# State of California Department of Public Works Division of Highways Materials and Research Department November 1961

SAN JOSE STATE COLLEGE

SOUND SURVEY OF VENTILATION SYSTEM NOISE

IN SPEECH-DRAMA BUILDING ADDITION

### RECOMMENDED ACOUSTICAL TREATMENT

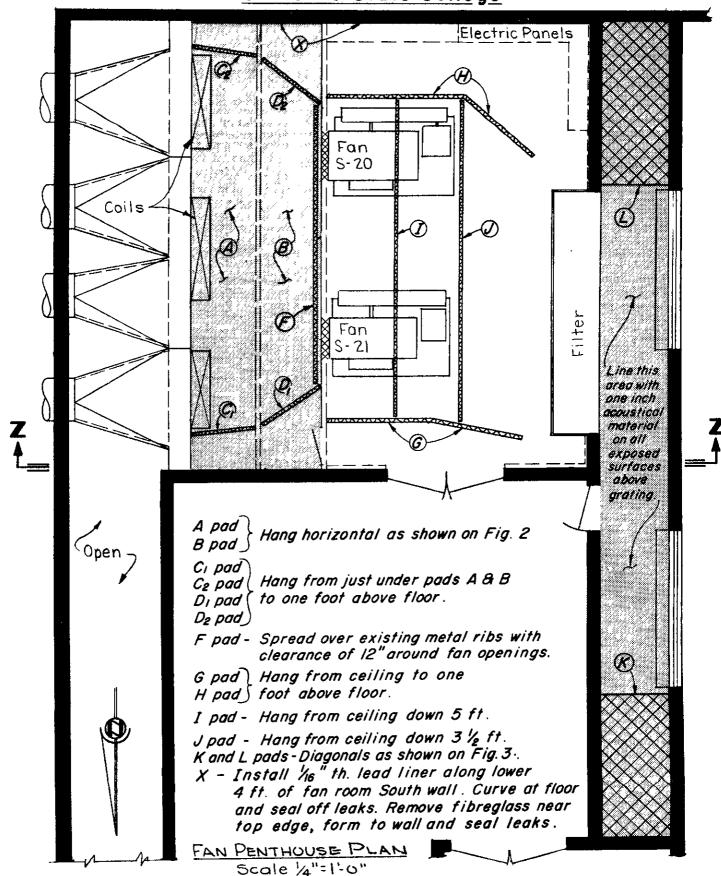
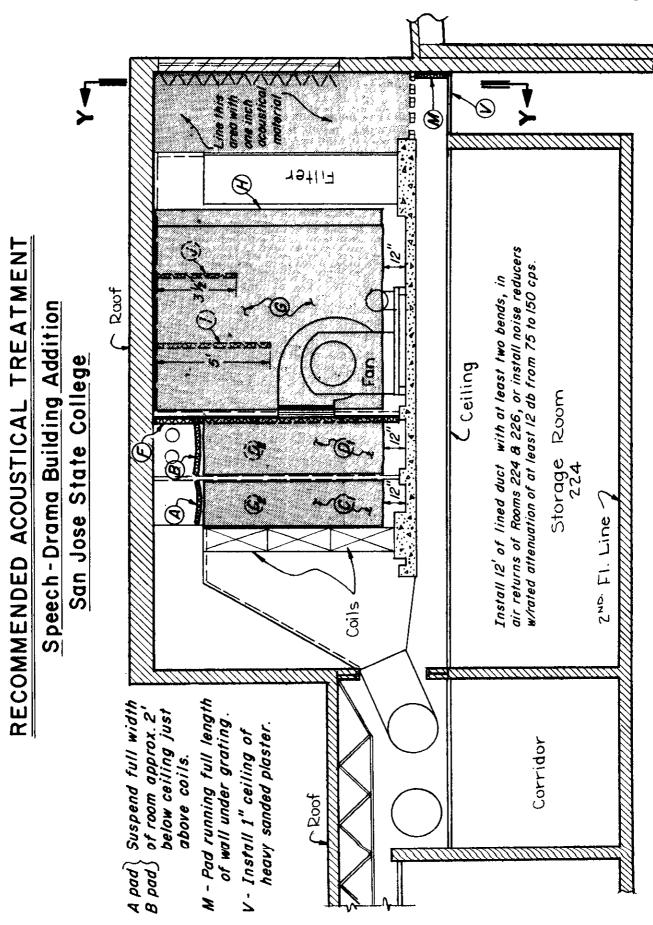
Recommended acoustical treatment and modifications are shown on Figures 1, 2, and 3. All acoustical pads are of the type shown on Figure 4. The materials recommended and method of fabrication are described.

Pads C1 and D1 (in Figures 1 and 2) should be wide enough so that they may be tied together where they meet at the dividing grille so as to minimize the air gap at this junction. The same comment applies to pads C2 and D2.

In the lower edges of pads G and H will have to be secured to prevent movement.

The diagonal pads K and L, in the return air shaft (Figures 1 and 3), should be mounted with their edges snugly against the walls to minimize air gaps at all pad edge and wall junctions.

Ceiling V (Figure 2) should be built as a standard ceiling to seal off the unused portion of the return air shaft and reduce noise penetration to Rooms 224 and 226.

The lead (metal) liner X along the lower south side of the fan room (Figure 1) reduces noise penetration into the return air space above the rooms.

Instructions on Figure 2 recommend means for reducing noise penetration via the return air openings in Rooms 224 and 226.

### ACOUSTICAL PAD CONSTRUCTION (Typ. const. of pads lettered A thru. M)

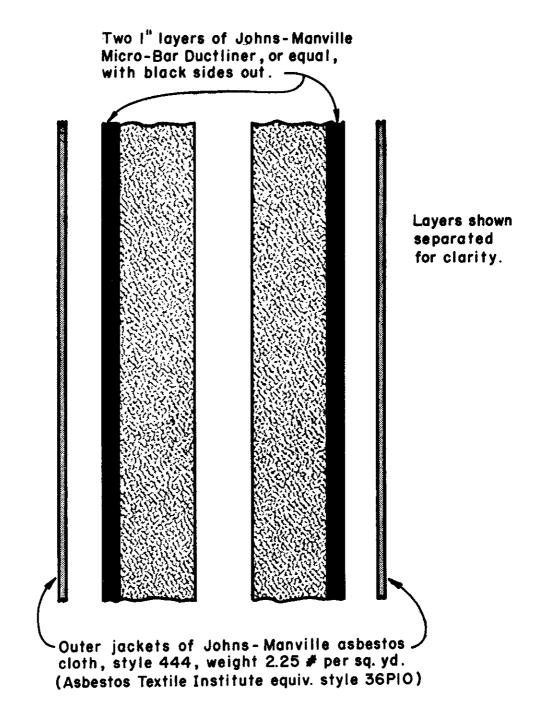
Outer sewn edge of pads shall be an overlap of the asbestos material and shall have metal ferrules every 12 inches (or as desired) for mounting.

Supporting hardware and ties at the discretion of the

Division of Architecture.
